MYALL RIVER DOWNS PTY LTD
MYALL RIVER DOWNS
WATER MANAGEMENT REPORT

Appendix 3 - WorleyParsons' Response to BMT WBM Review of Draft Water Management Strategy (3rd March 2009)

MYALL RIVER DOWNS, TEA GARDENS - RESPONSE TO REVIEW OF FLOODING, STORMWATER AND GROUNDWATER ASSESSMENTS

APPENDIX A – ADDITIONAL INFORMATION

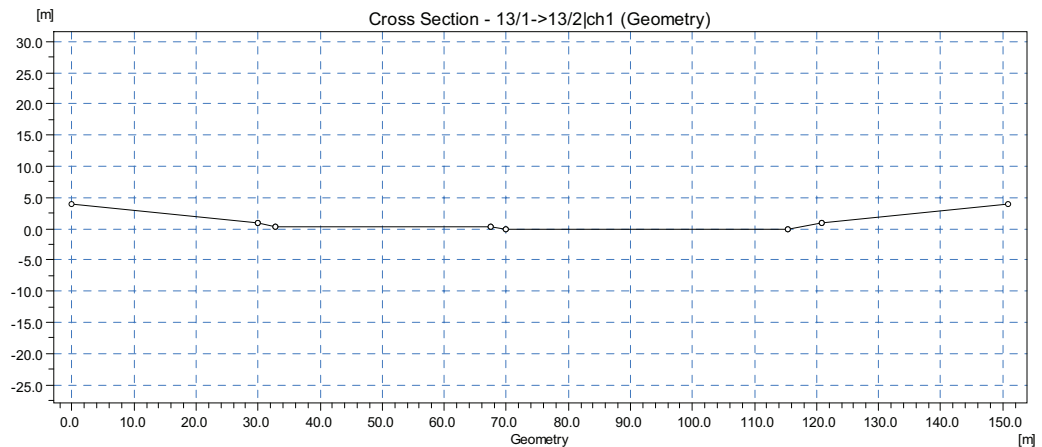
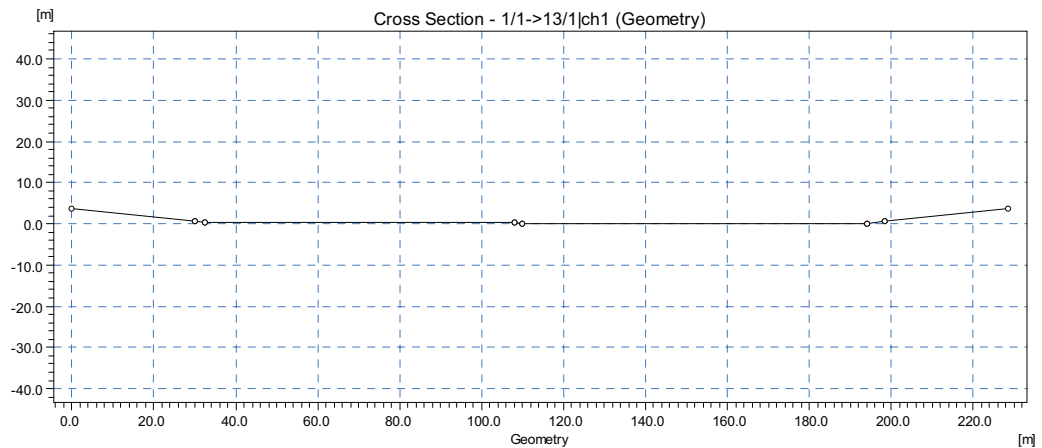
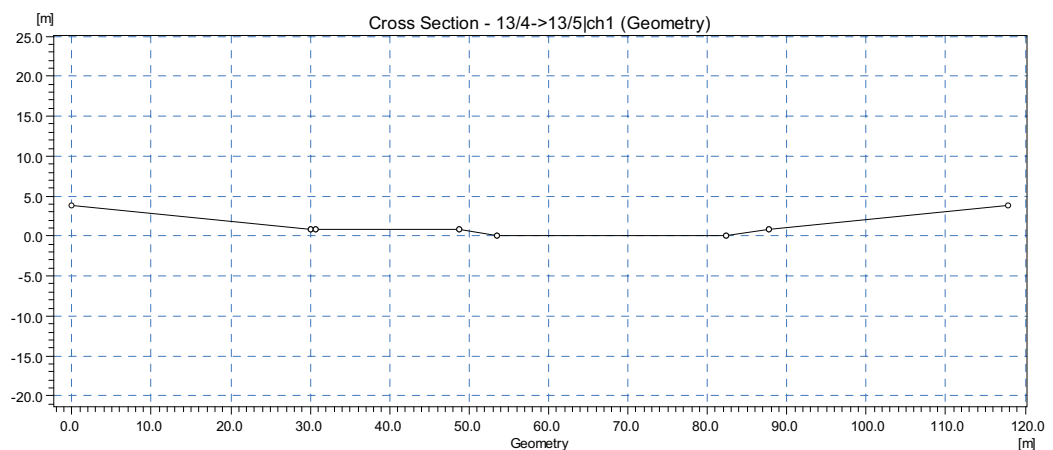
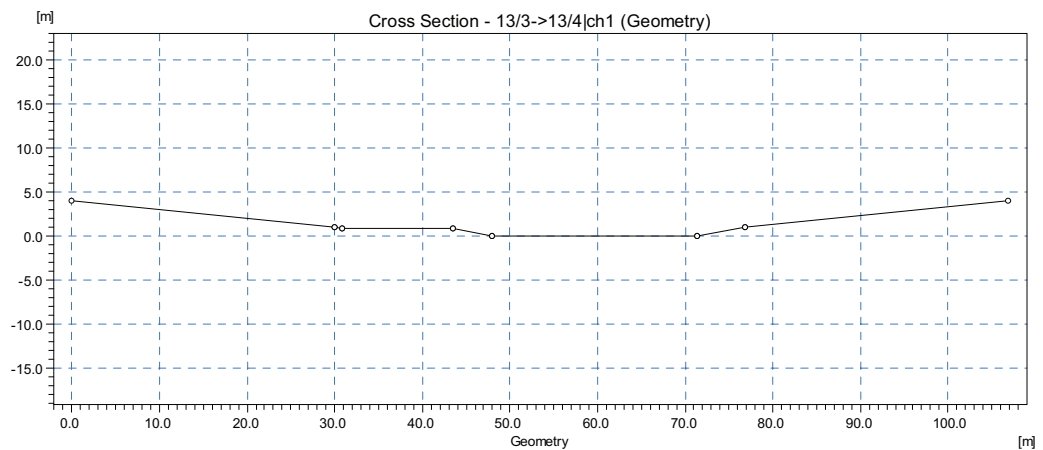
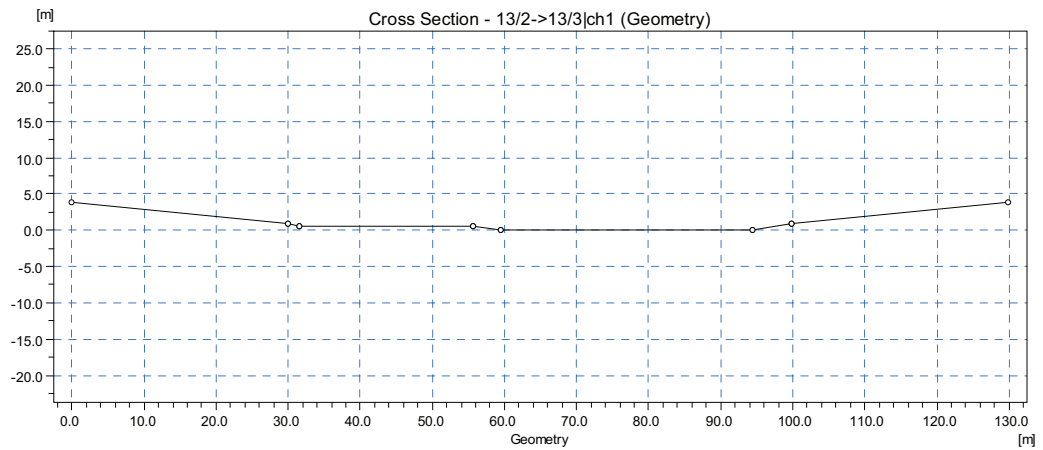
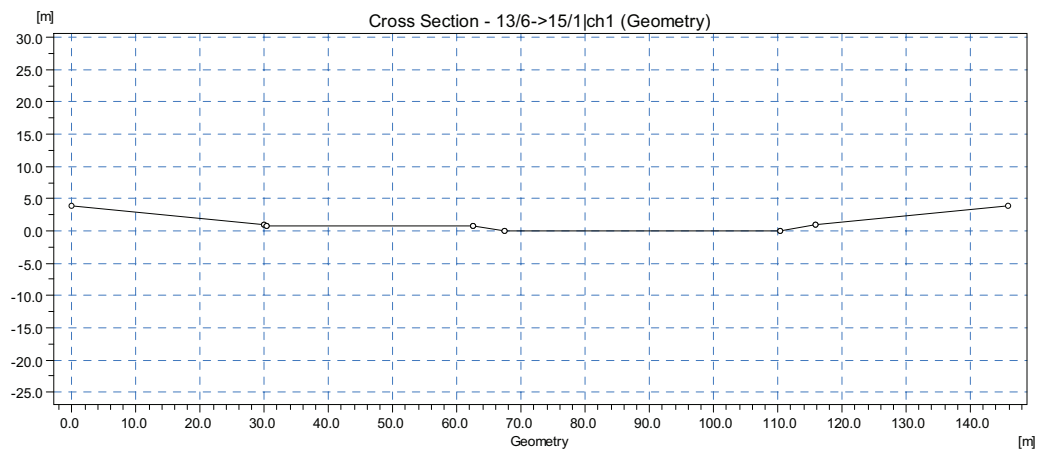
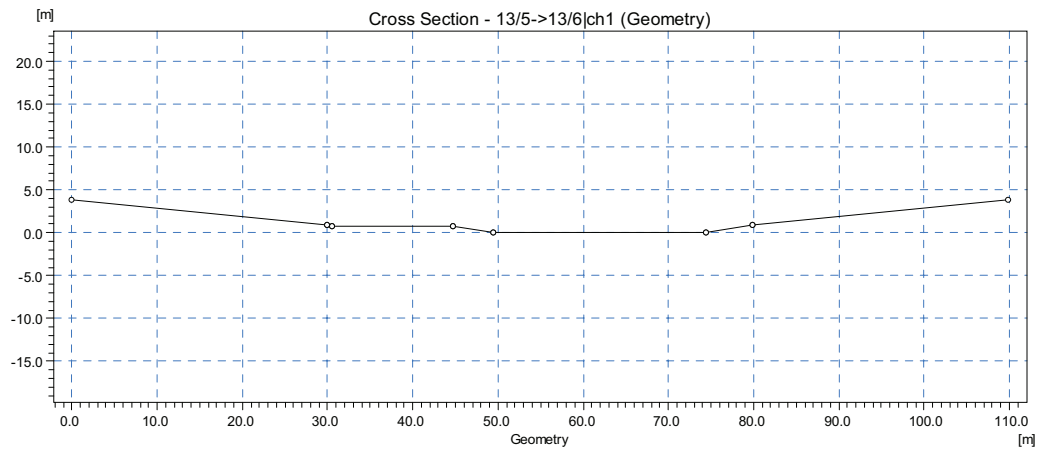
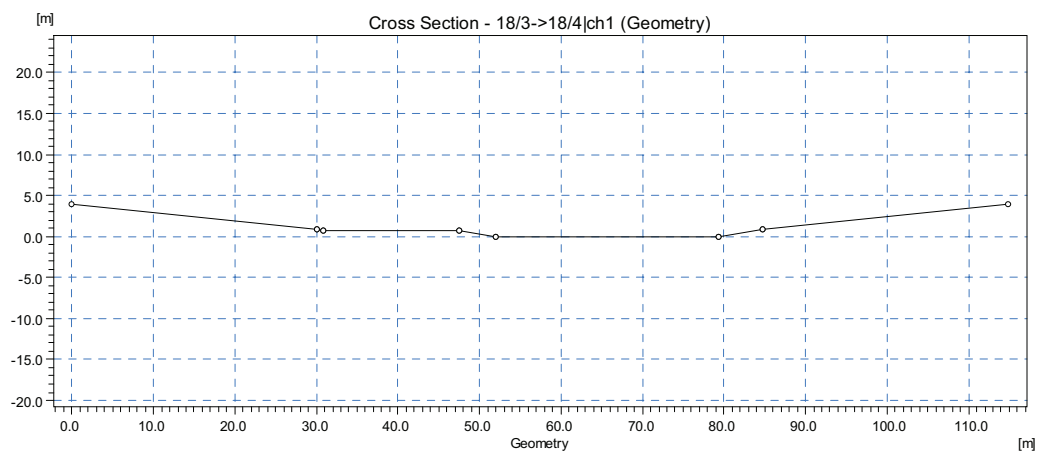
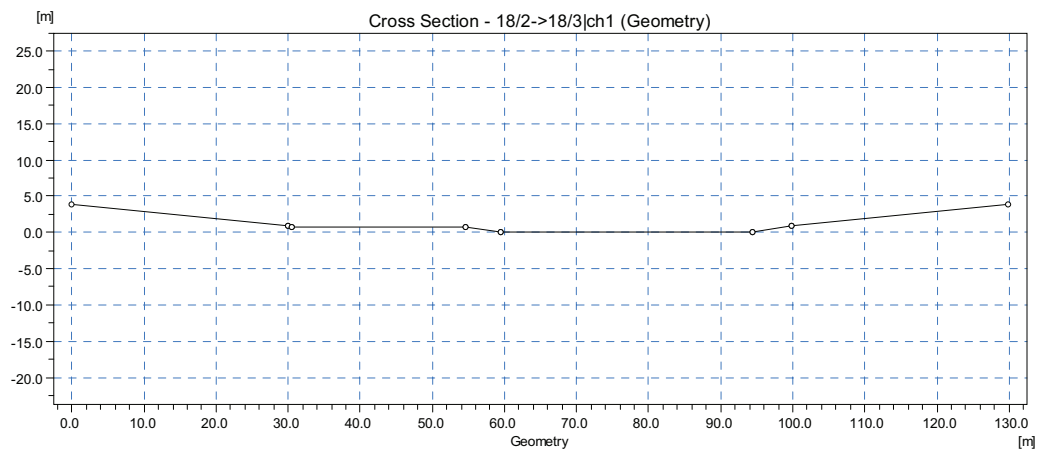
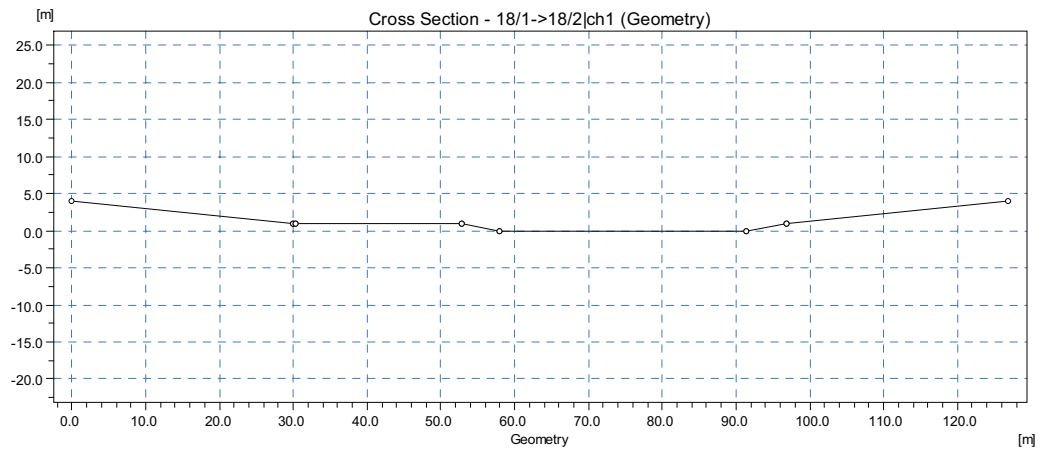
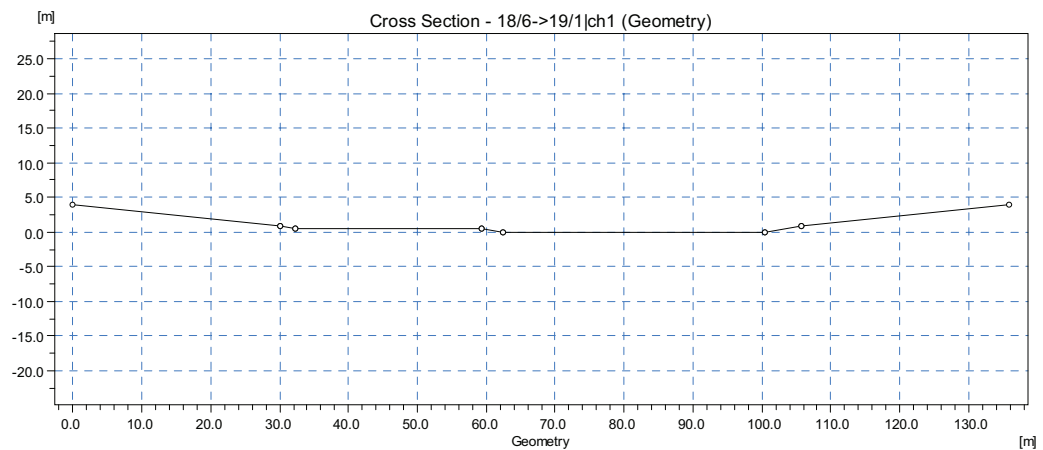
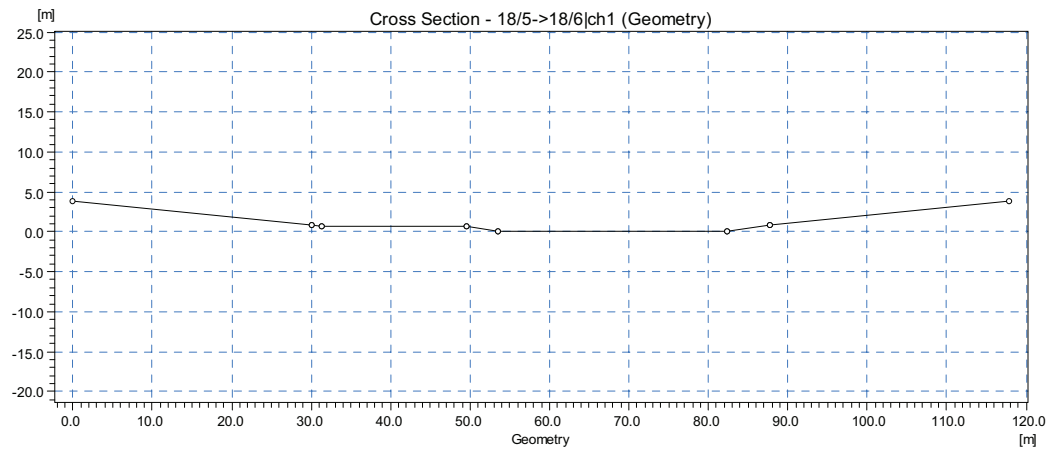
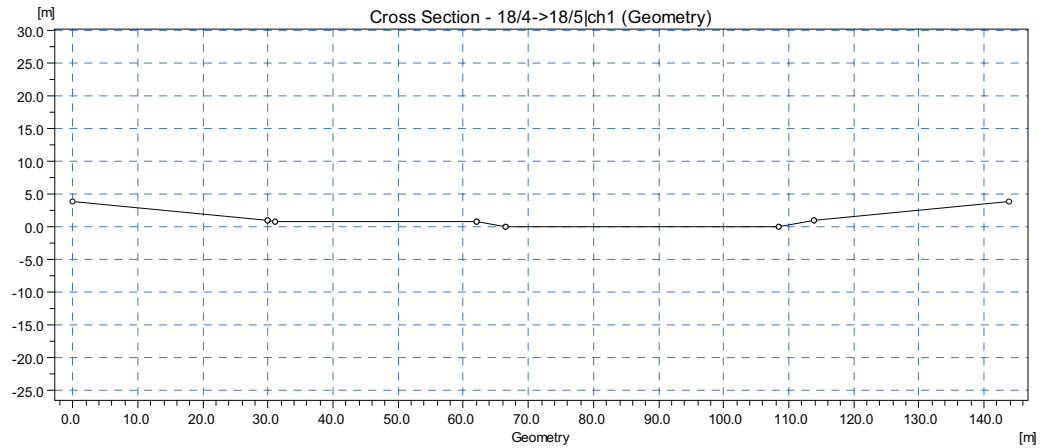
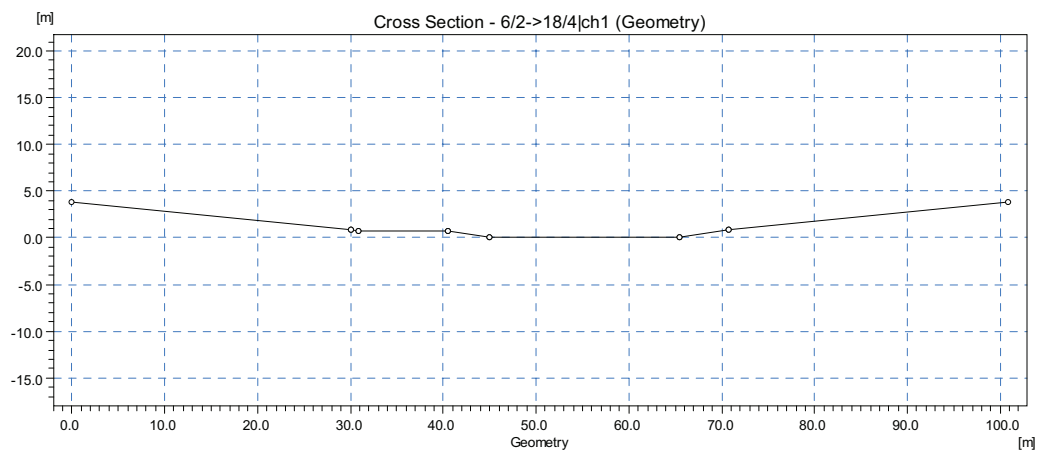
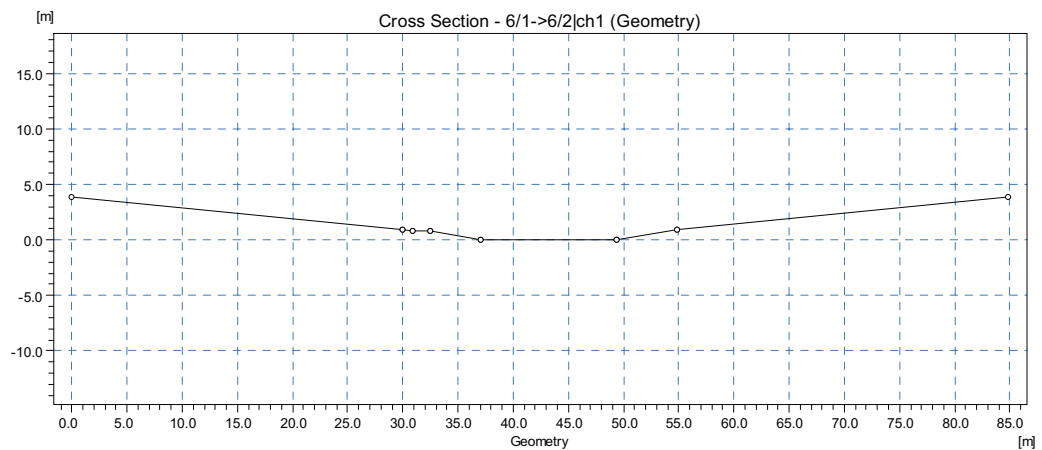
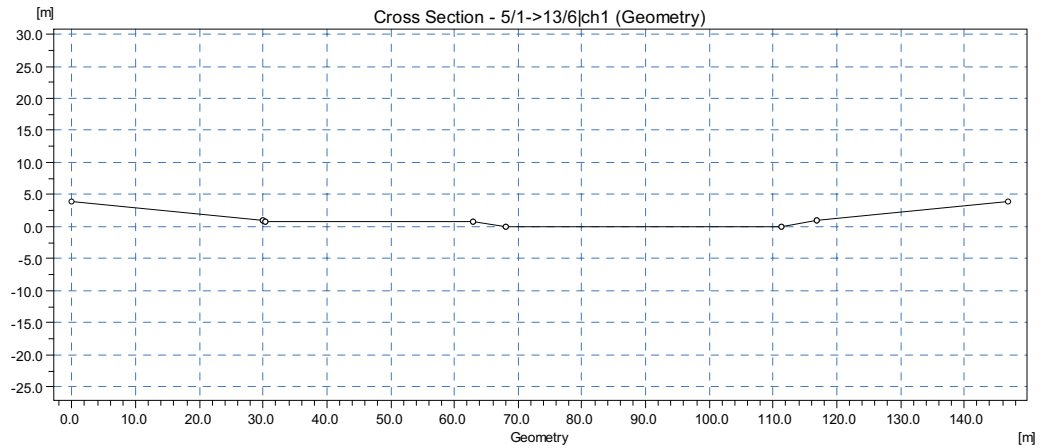
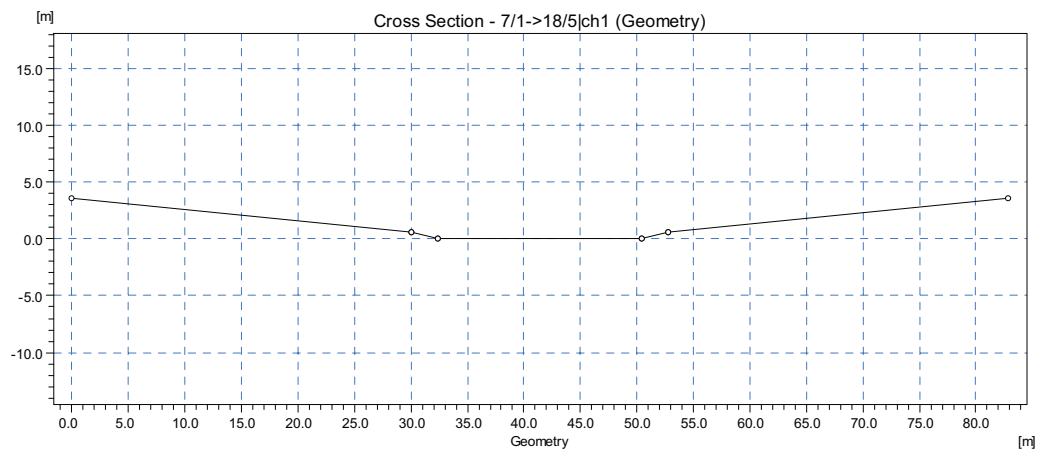
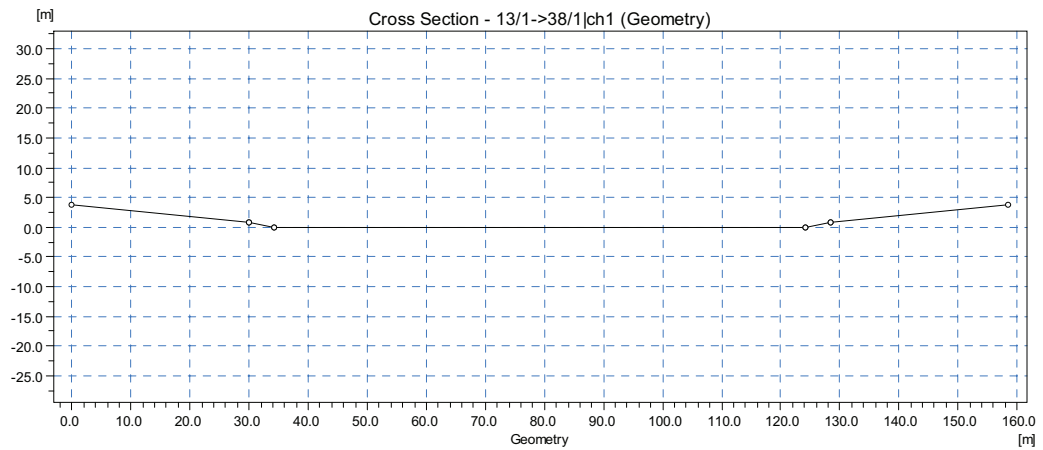
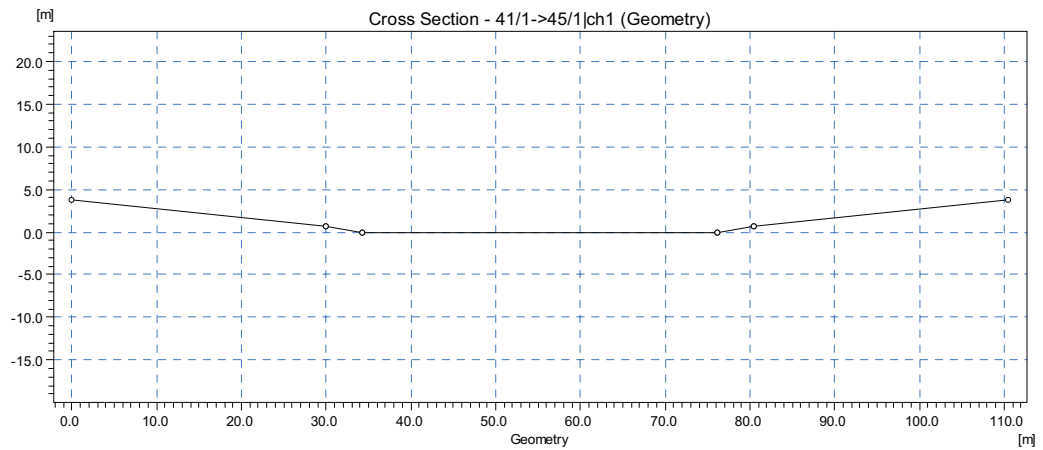
16. Limited information is provided in the report regarding the dimensions of the modelled channels. Depths and side slopes are provided, but no details on the modelled widths are provided. The report indicates that 'channel widths were estimated from the masterplan'. It is considered that this information should be provided in the report.

Channel geometry is provided below.
